LARAMIE COUNTY PLANNING & DEVELOPMENT DEPARTMENT

TITLE: PUBIC HEARING regarding a Subdivision Permit and Plat for Saddleback

Acres, 2nd Filing, a re-plat of Lot 1, Saddleback Acres, Laramie County, WY.

PZ-19-00235 SADDLEBACK ACRES, 2ND FILING SUBDIVISION PERMIT 2nd Review

FINAL PLAT

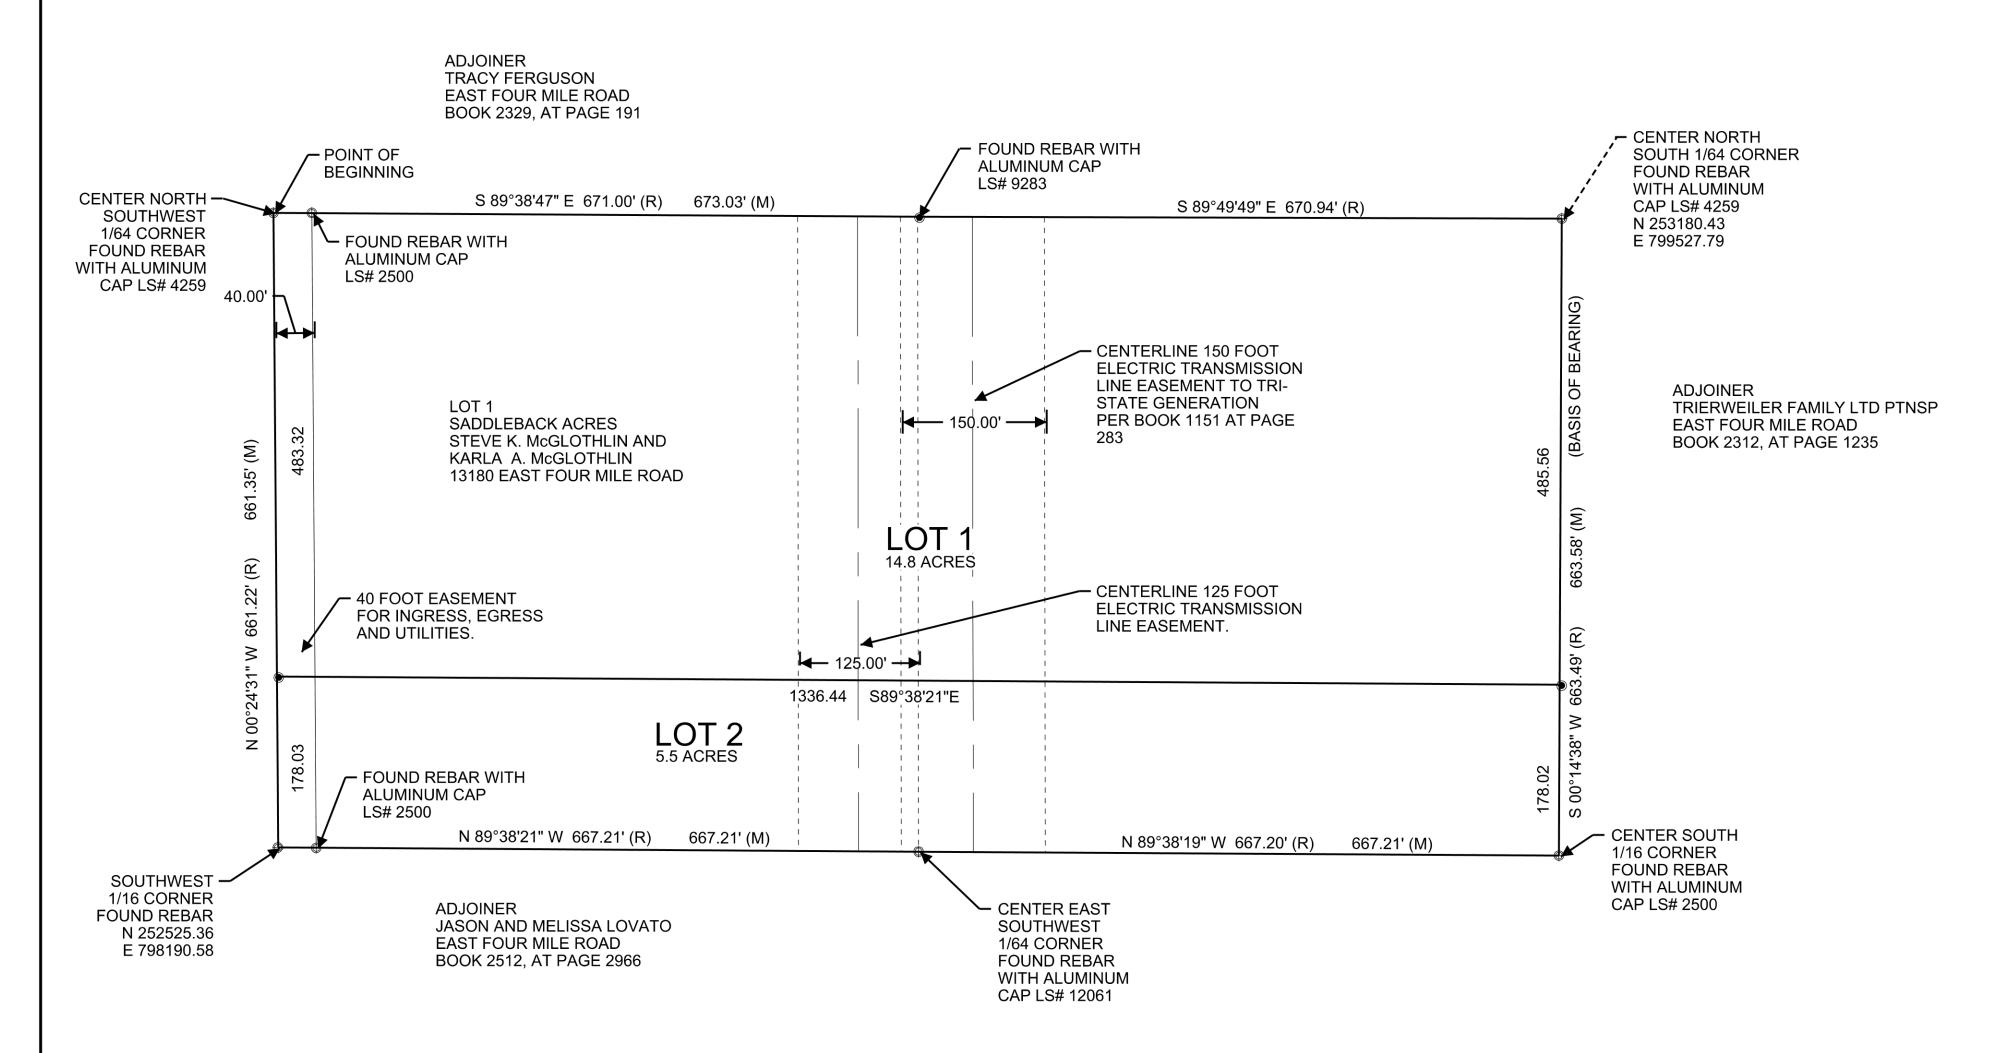
- 1. The owners signatures and the Notary Acknowledgements need to be together. The acknowledgement needs to directly follow the signatures that they are notarizing.
- 2. The Acknowledgement still needs to have the name printed/typed in for the owners after the "by".

- 1. In Miscellaneous Notes number 10, "LOAND" should be "LAND".
- 2. The 125 foot electric transmission line easement needs to include the Book and Page number for the recorded easement.
- 3. I the Certificate of Surveyor it indicates "that this Map of Survey..." and it should read "that this Final Plat...".

- 1. Is the West 40' EASEMENT FOR INGRESS, EGRESS AND UTILITIES, shown as part of Lots 1 and 2, PROPOSED to be all or part of Sherry Road? If it is, it should be labeled SHERRY ROAD and the TOTAL width of the road right-of-way should be shown on the plat.
- 2. The East boundary of the 125.00' wide ELECTRIC TRANSMISSION LINE EASEMENT (running North-South) located approximately in the middle of the subdivision is shown as falling on the line between 2 survey monuments, LS #9283 at the North end and LS #12061 at the South end. However, there are no boundary ties shown for the 150.00' wide ELECTRIC TRANSMISSION LINE EASEMENT and it is not specifically tied to the overlapping 125.00' wide ELECTRIC TRANSMISSION LINE EASEMENT.
- 3. Generally the ACKNOWLEDGEMENT for the DEDICATION is located immediately adjacent to or under the DEDICATION.
